Pleasant Grove Wastewater Treatment Plant Expansion and Energy Recovery Project

Addendum to the CEQA-Plus Initial Study/Mitigated Negative Declaration

June 2018

**CITY OF
ROSEVILLE**
CALIFORNIA
311 Vernon Street
Roseville, CA 95678
Contact: Mark Morse
(916) 774-5499

Energy Recovery Project Revised PG&E Pipeline Location

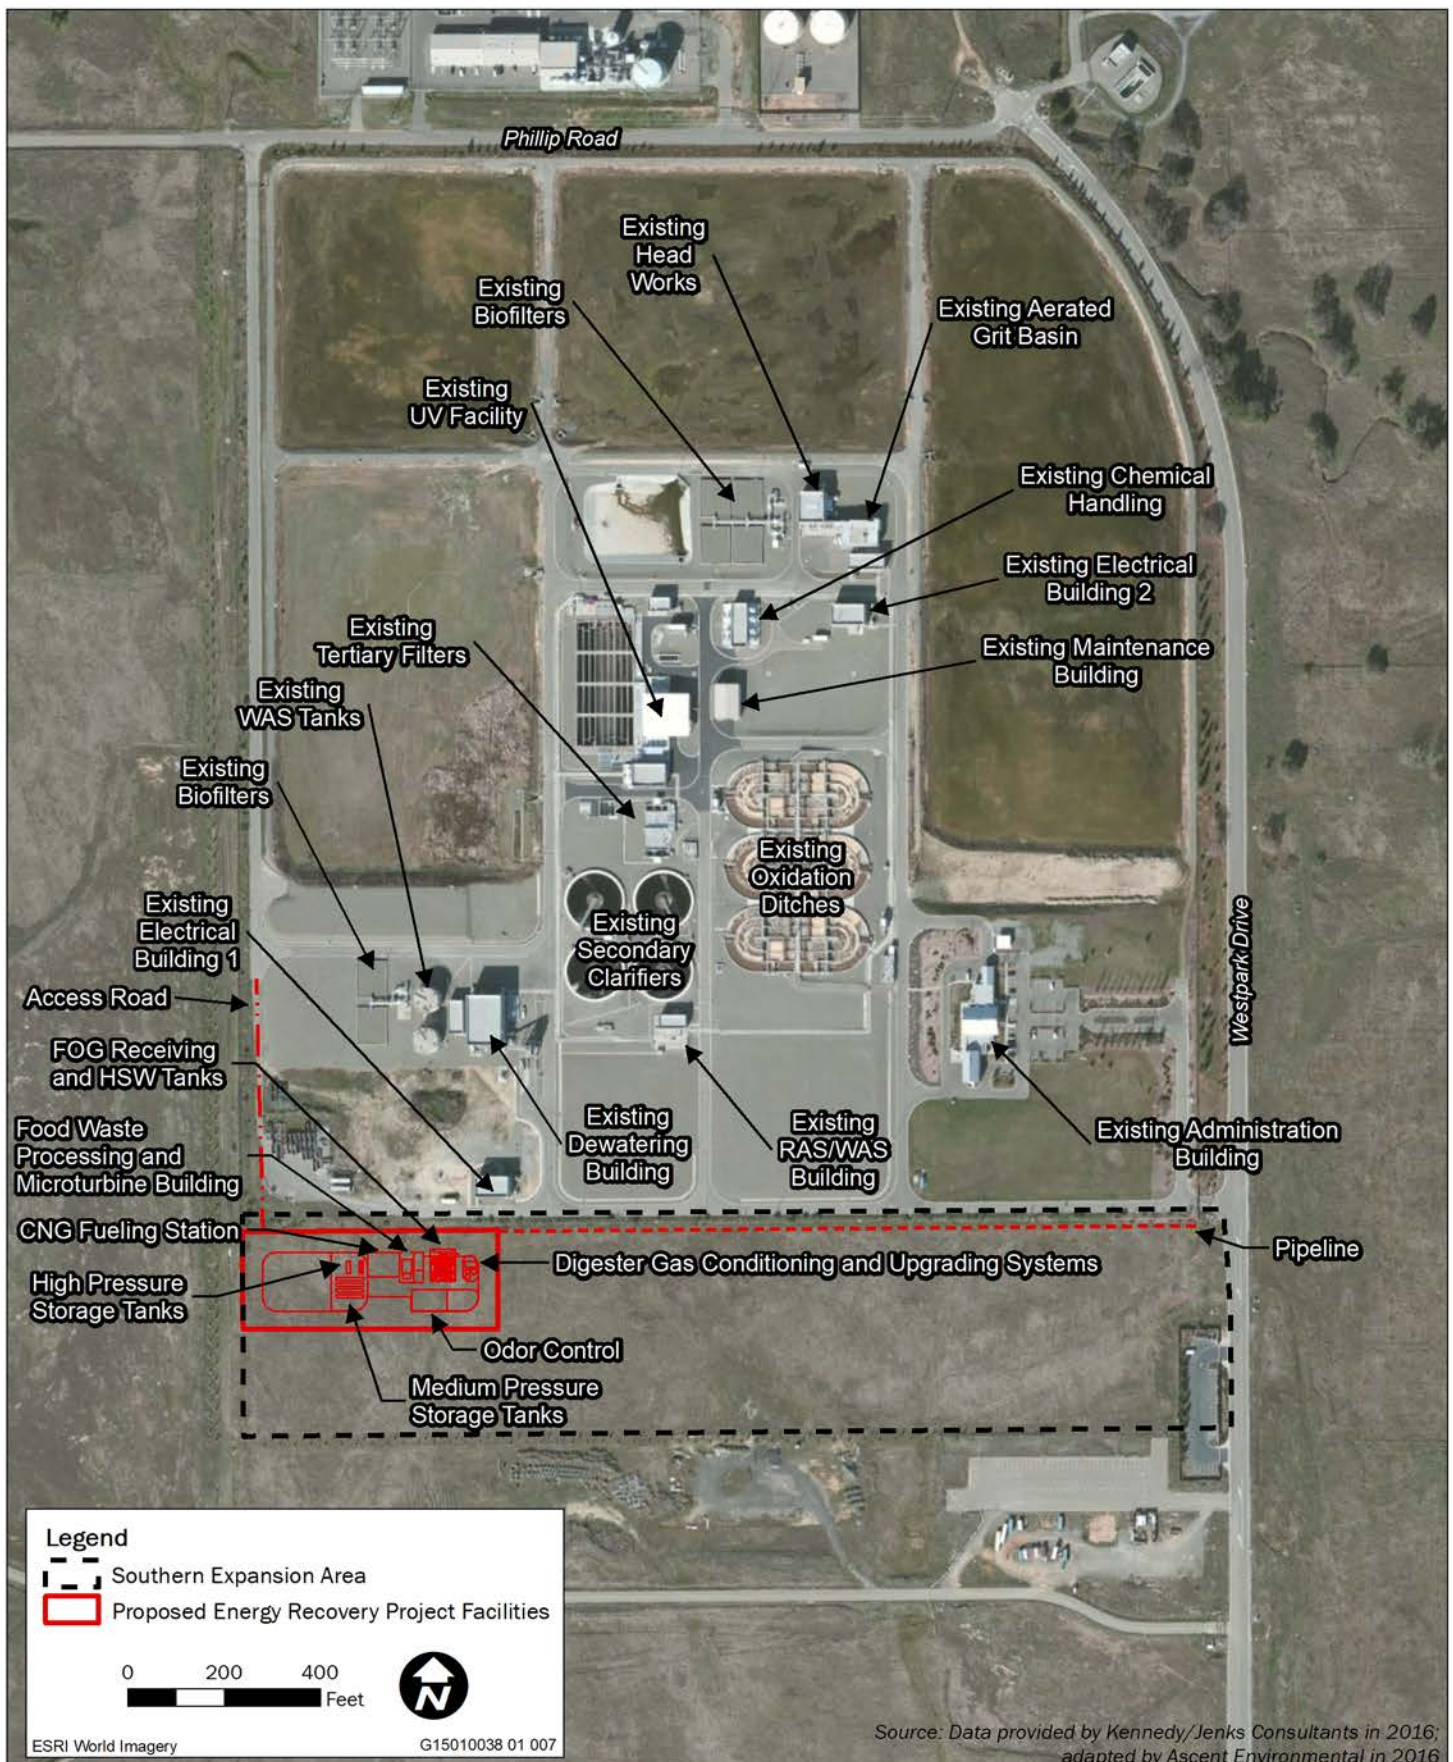
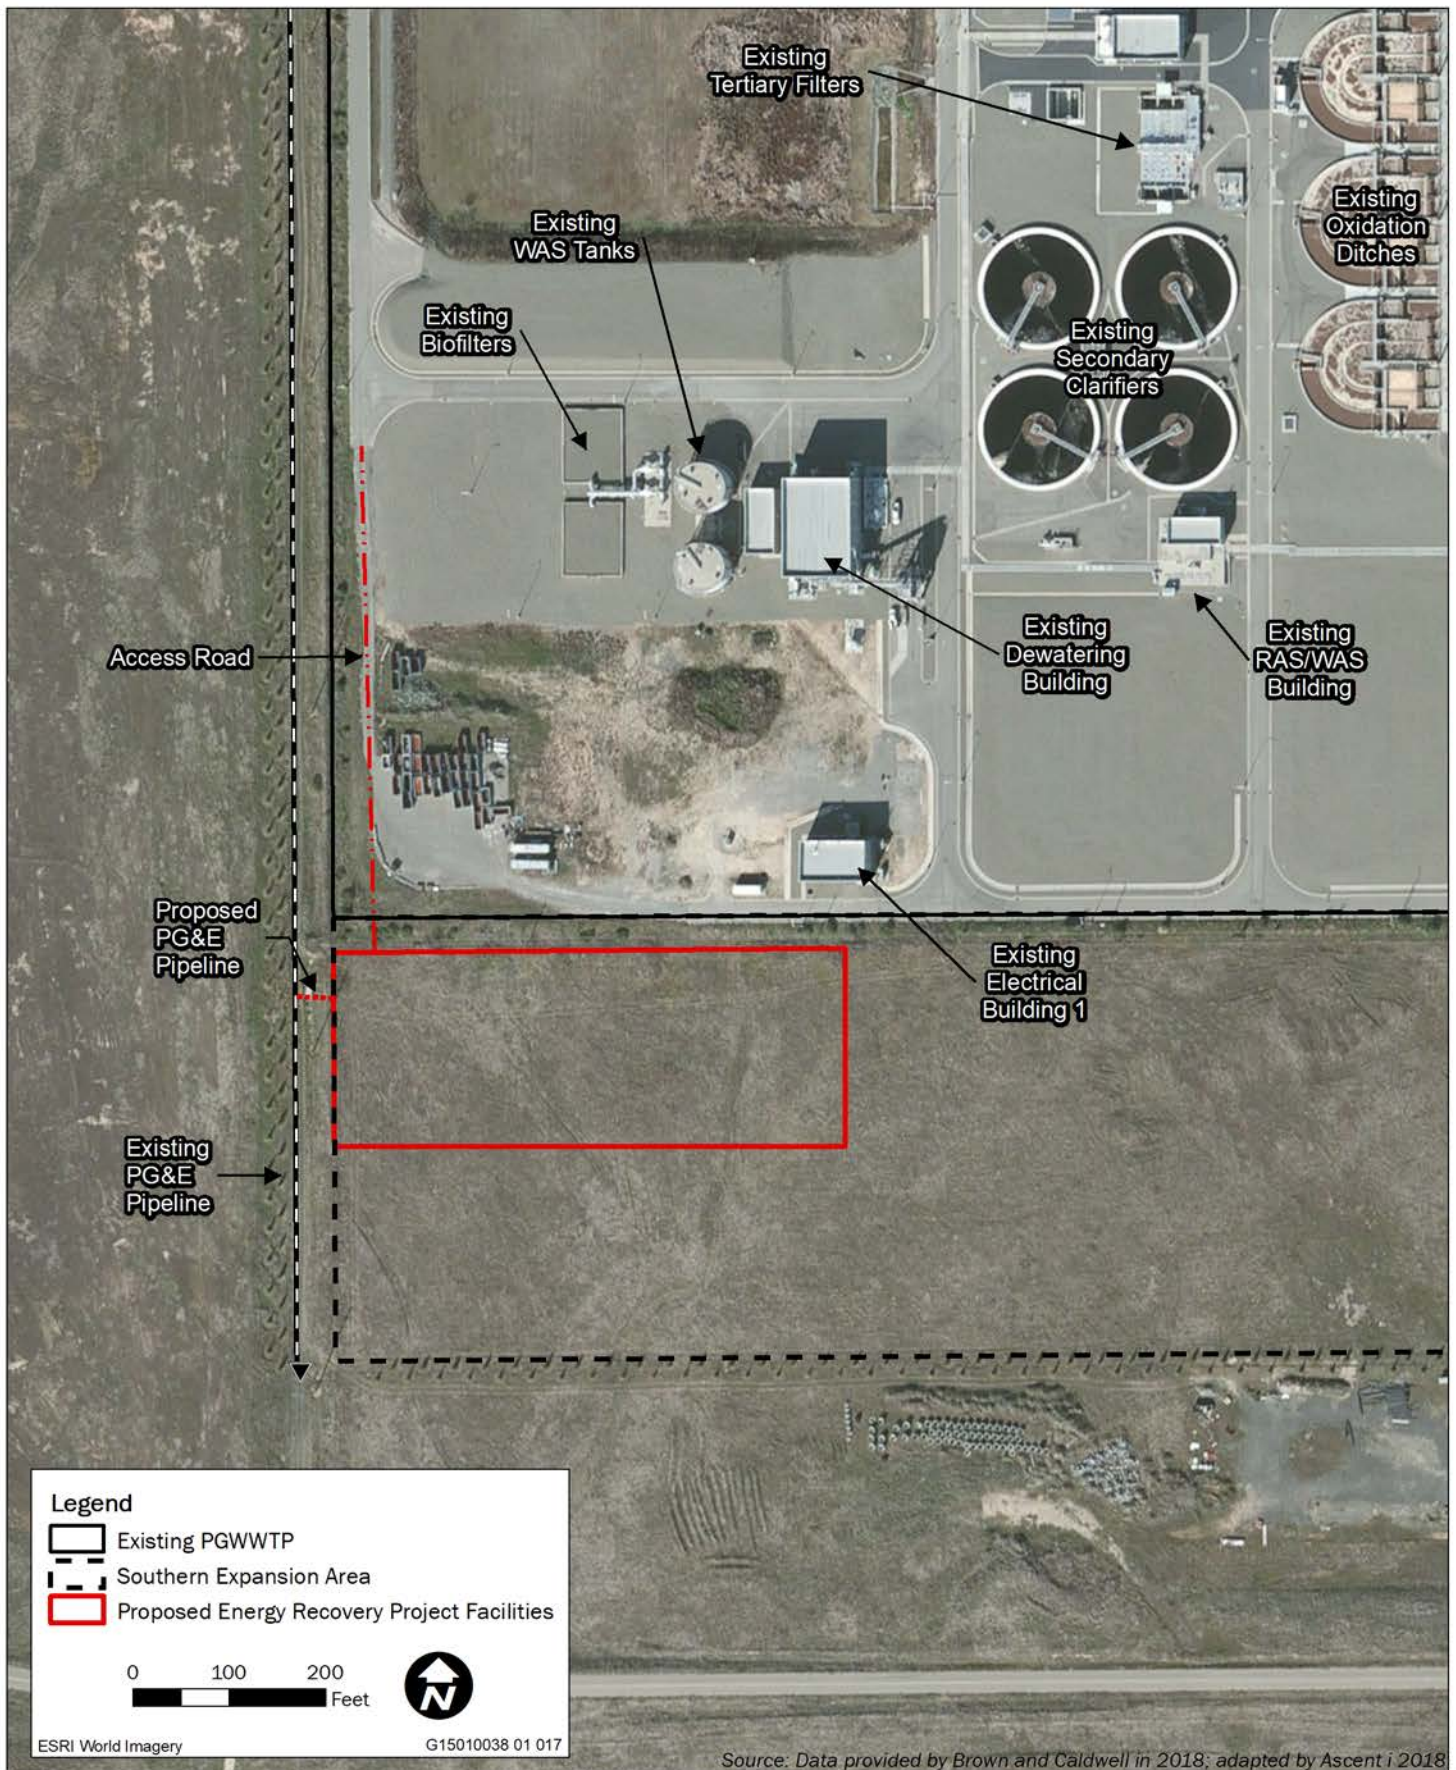
The 2017 IS/MND assumed a 4-inch CNG pipeline would be constructed from the PG&E main along Westpark Drive to serve the Energy Recovery Project. The pipeline was previously described as being located south of the southern boundary of the existing PGWWTP within the Southern Expansion Area. The proposed pipeline extended east to connect the Energy Recovery Project area to the existing PG&E main along Westpark Drive (Exhibit 2-1). The proposed pipeline location has been revised to extend from the Energy Recovery Project area to the existing PG&E gas main located along the western fenceline of the City's property (Exhibit 2-2) (approximately 40 feet of pipeline). The relocated pipeline would still be 4-inch in diameter; however, the length of pipeline would be less than the pipeline previously analyzed in the 2017 IS/MND.

The relocation of the PG&E pipeline as a modification to the adopted MND would require disturbance of undeveloped land to the west of the project area evaluated in the 2017 IS/MND. Potential effects to the expanded footprint are addressed in Section 3.2, "Impact Analysis," below.

Revised Staging Locations

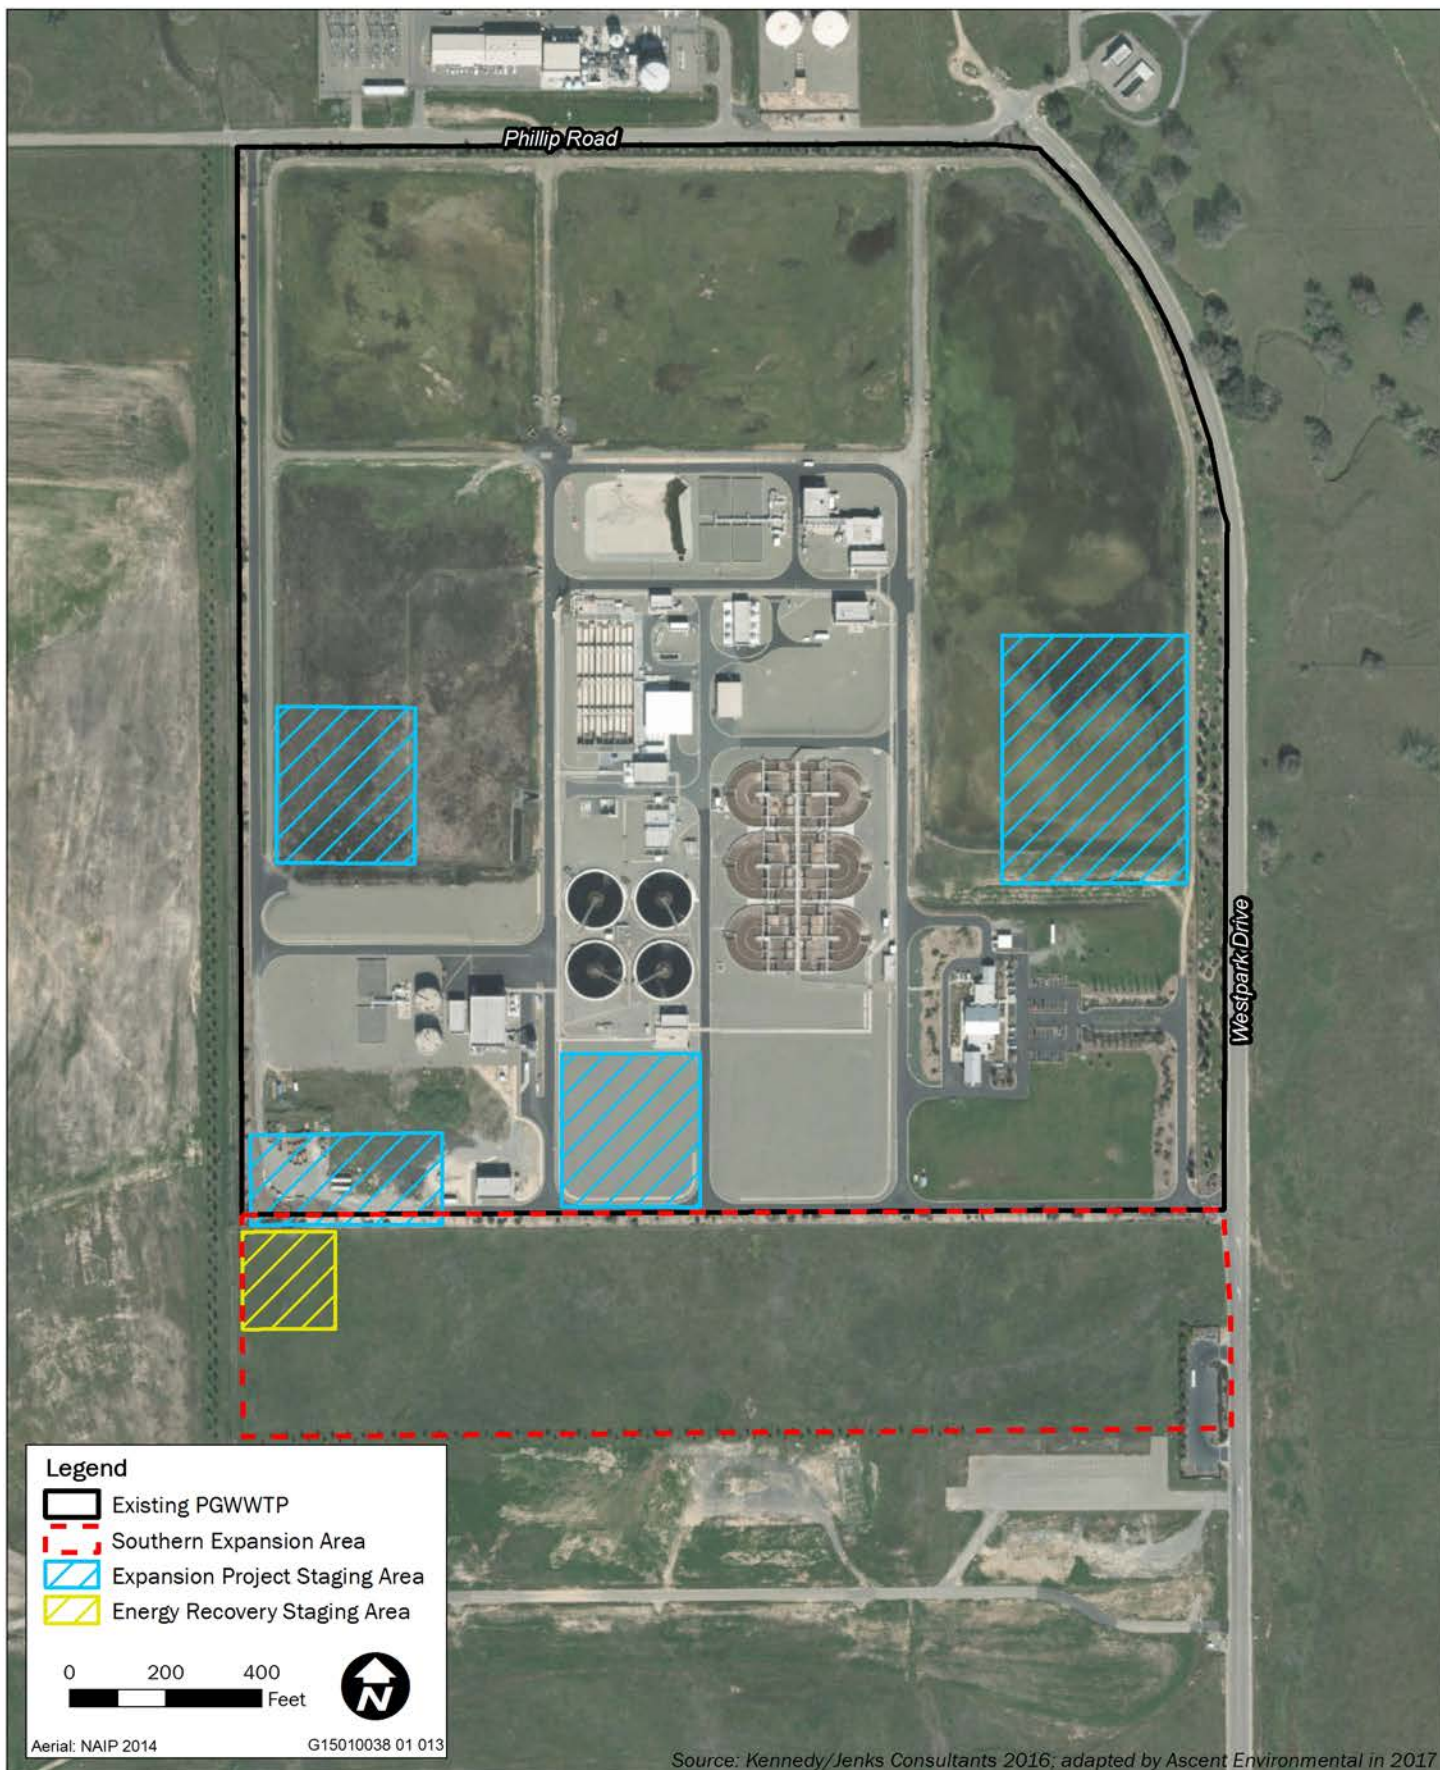
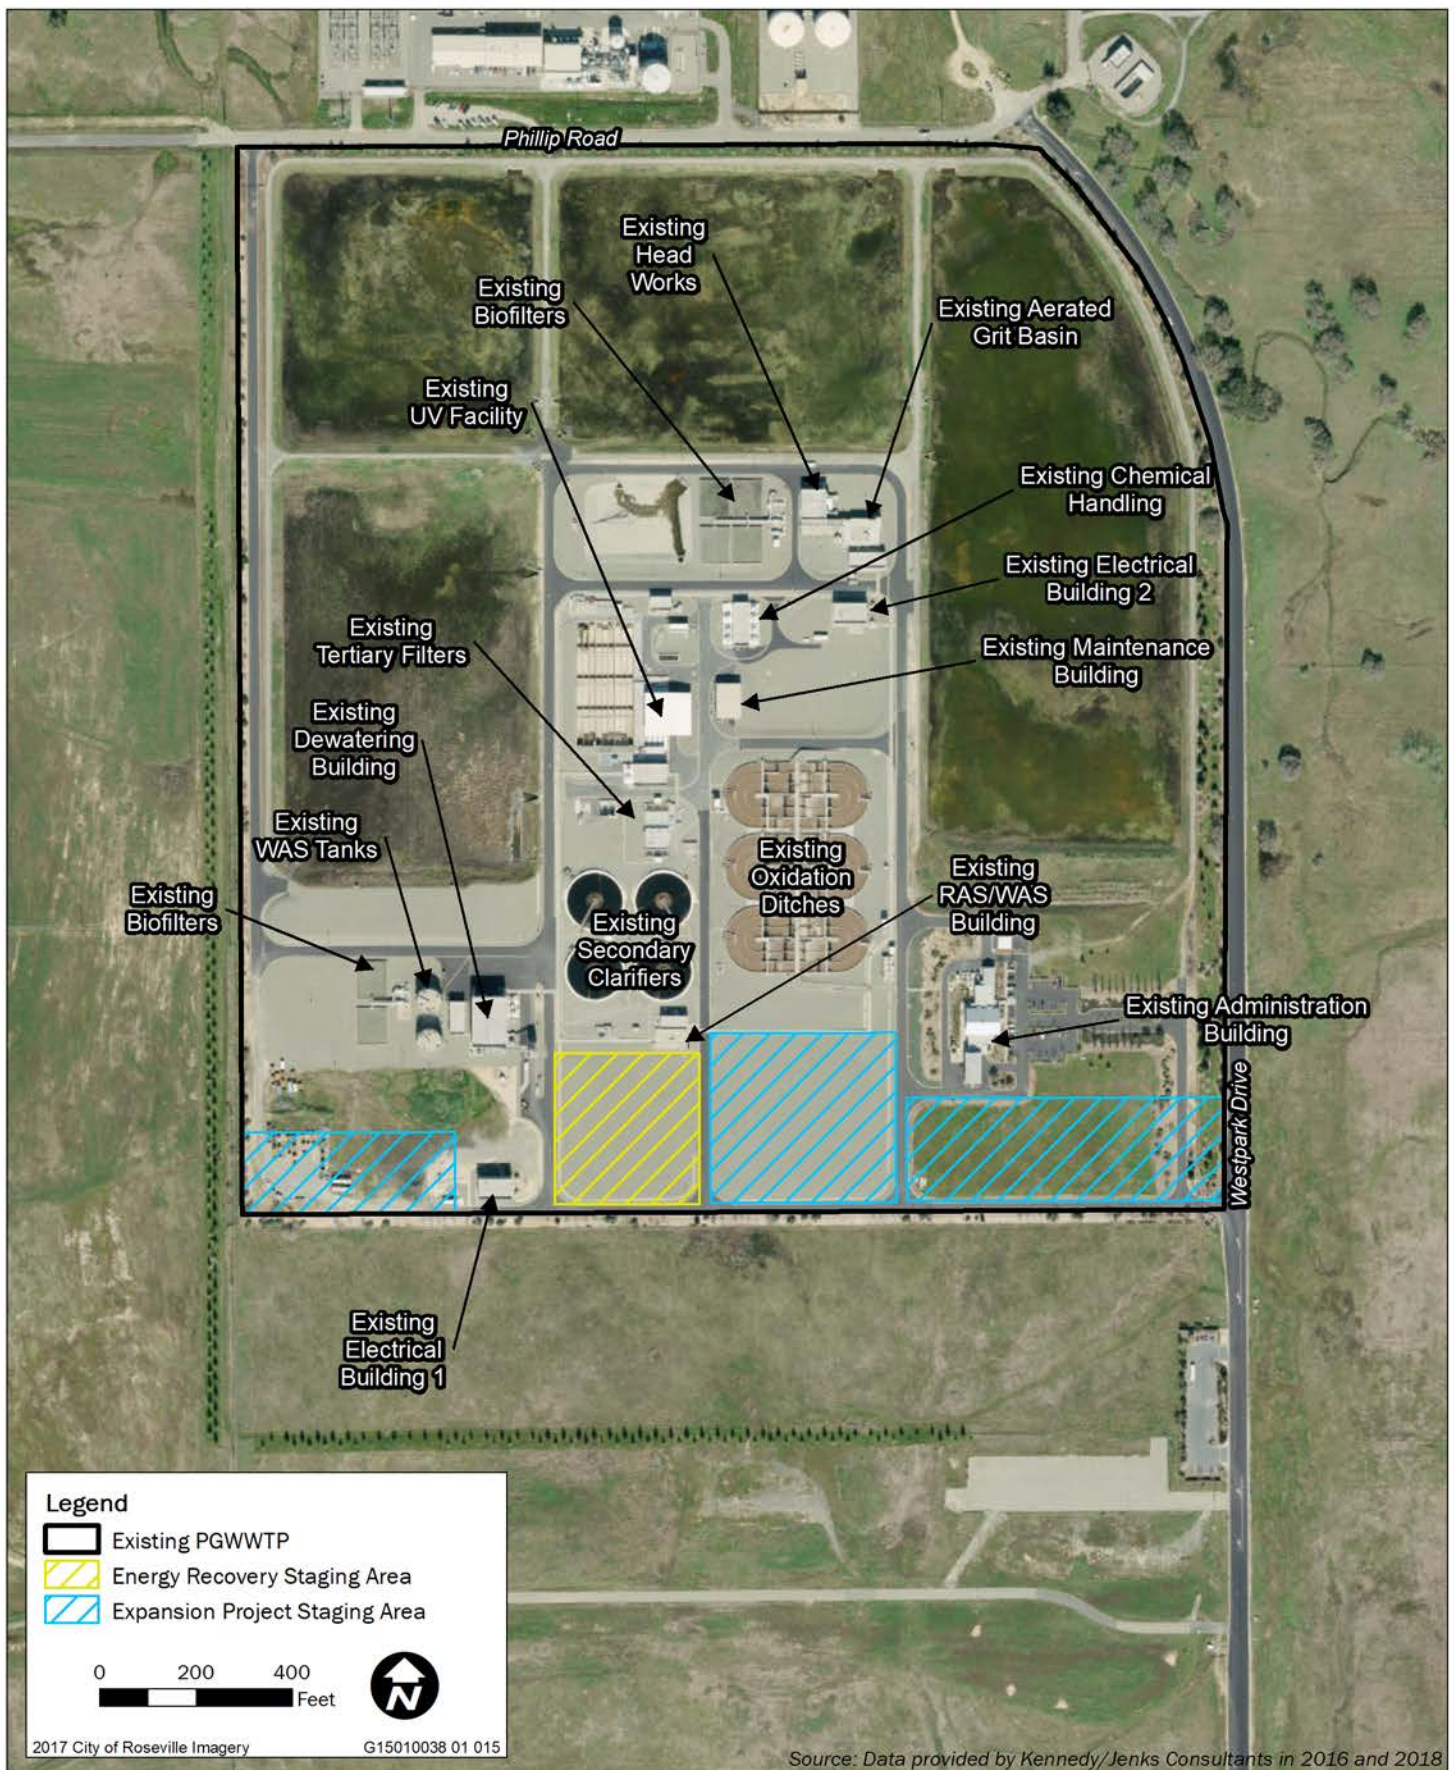
The 2017 IS/MND assumed up to four staging areas would be used for construction of the Expansion Project and one staging area for the Energy Recovery Project (Exhibit 2-3). Through refinement of the design, it was determined that not all of the staging areas identified previously are feasible locations for construction staging. The proposed locations of the staging areas have been revised as shown in Exhibit 2-4 including moving the proposed Energy Recovery Project staging area to a disturbed area within the PGWWTP boundary. In addition to the staging areas identified, other previously disturbed areas within the PGWWTP boundary could be made available for construction staging as approved by the City. However, all staging areas would be within the fenceline of the existing PGWWTP and would either be paved or previously disturbed. Any disturbance or treatment facility development occurring within the PGWWTP fenceline was already evaluated and approved consistent within the *Roseville Regional Wastewater Treatment Service Area Master Plan EIR* (City of Roseville 1996).
